Rezoning Transportation Analysis

Petition Number: 2018-161

Revision Log:

Date	Description
01-18-19	First Review

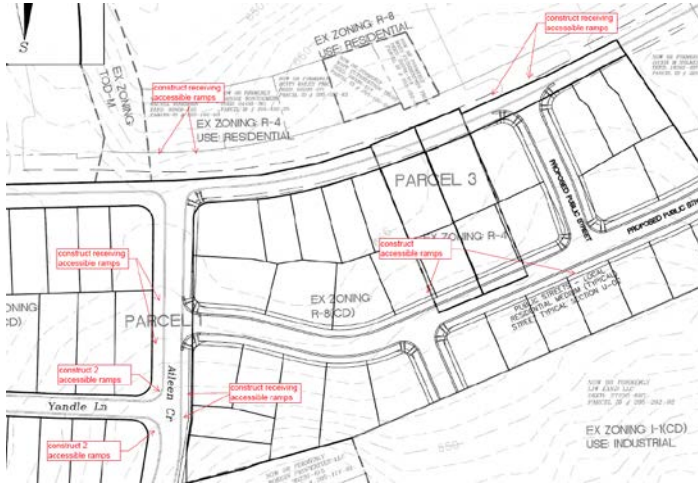
- ~~1. **Traffic Study** A Traffic Impact Study/Transportation Technical Memorandum is not necessary for the complete review of this petition.~~
2. The petitioner shall revise the site plan and conditional note to show the proposed east-west road aligning with existing Yandle Lane as discussed in the pre-application meeting. The proposed east-west street is the extension of Yandle Lane.
3. The petitioner shall revise the site plan and conditional note(s) to commit to construct an 8-foot planting strip and 5-foot wide sidewalk depicted on the site plan along China Grove Road from Aileen Circle to the eastern limits of the rezoning, and along Aileen Circle.
